(REVISED) APPENDIX E
TRAFFIC QUEUING ANALYSES

Subject: 556 El Camino Real - Parking

Re: *Peer Review of the Queuing Analysis Completed for the Proposed Residential Project at 556 El Camino Real in Burlingame, California*

BASEMENT (GARAGE) PLAN
 SCALE 3/16"=1'-0"

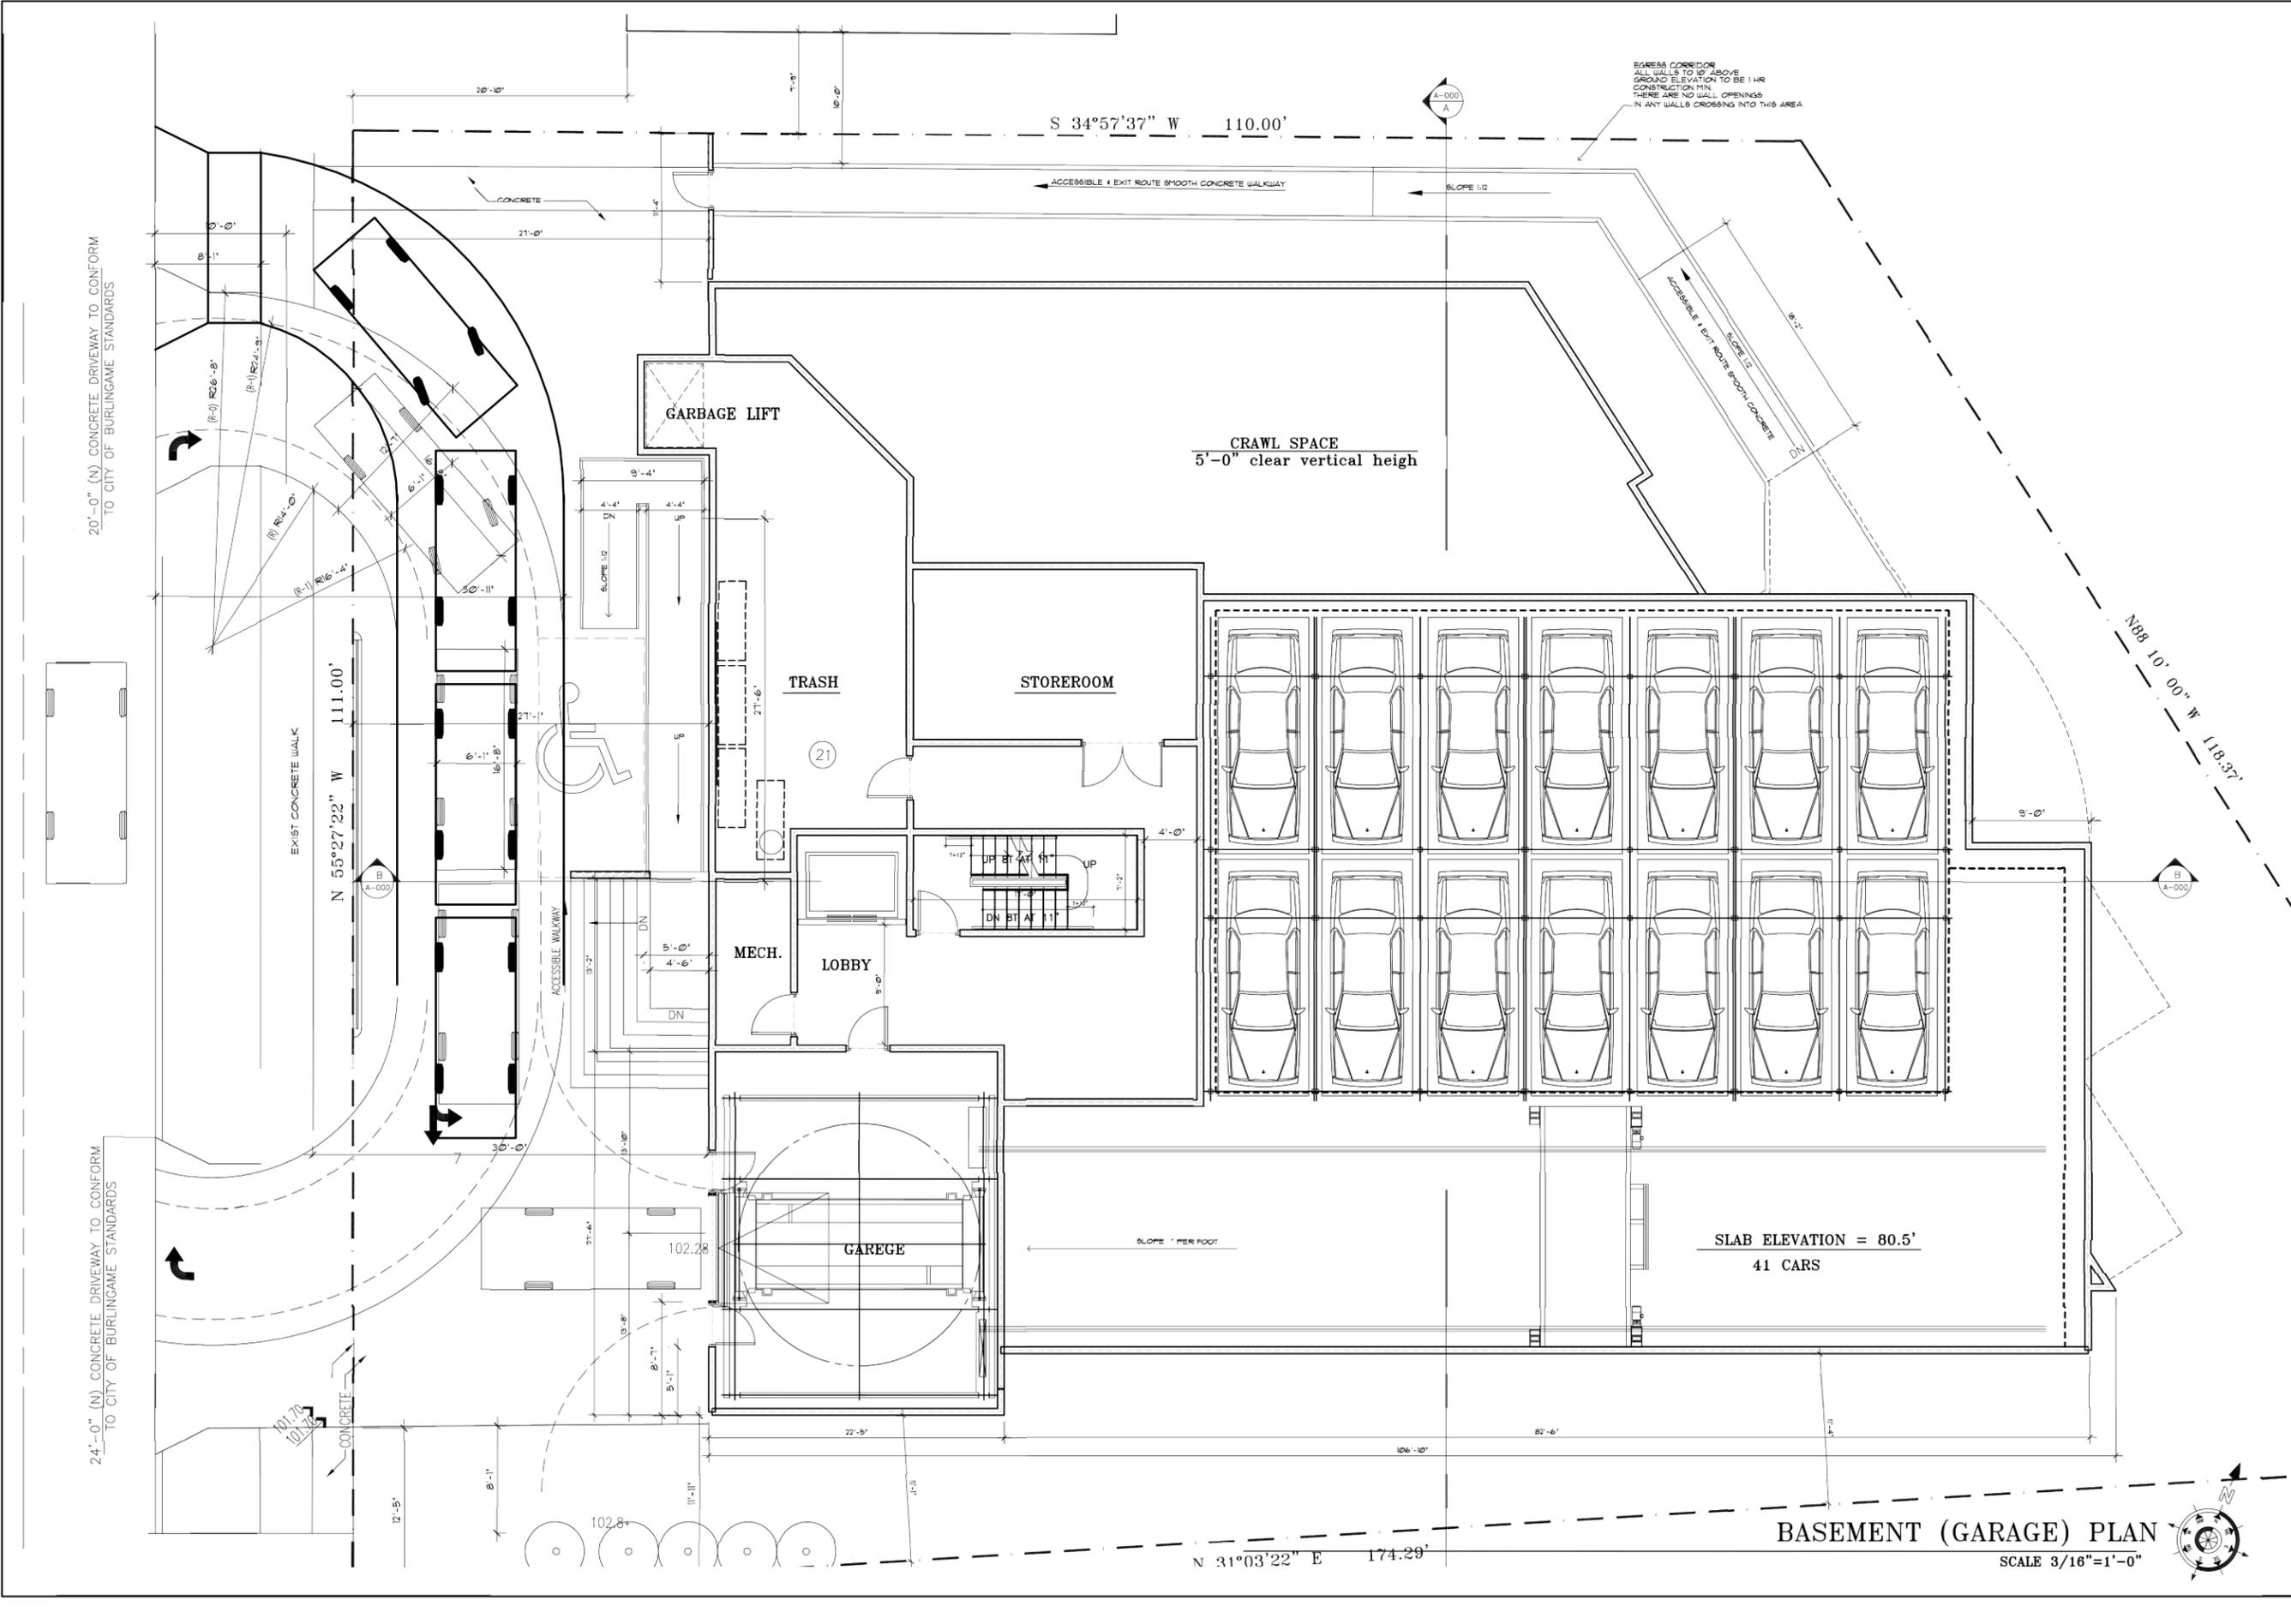
I have reviewed the information provided regarding a parking queue for residents while utilizing the automated parking structure. Based on the information provided, it appears that a traffic engineer has estimated that the peak 15-minute traffic rate generated from the new development would create a 3 car backup while operating the automated stacker. The current design provides ample room for three cars in the driveway, however the City is requesting additional space. It is unclear how many additional spaces the City is requesting.

It appears that room for a fourth car is almost available in the current design. Pulling building back from El Camino would only add one car, there is not enough space to add any more and maintain a single line. Extending the driveway closer to the property line would be more effective since there is more space to increase driveway length. Regardless, alternative means may be preferable to avoid backup on El Camino Real. My recommendations are summarized below:

Methods for improving circulation:

- Lengthen driveway towards the property's westerly boundary. This shift would be more effective than pulling back from El Camino since there is more space in that dimension.
- A fourth car would create a factor of safety of 33%, which seems adequate for this project.
- Notify future residents that blocking ECR is not allowed. If the queue is full, residents must circle the block.
- Provide signage to this effect as requested by traffic engineer.
- Paint stripes in driveway to place cars in order. This could prevent excessive separation between cars and show incoming residents whether all spaces in the queue are full.
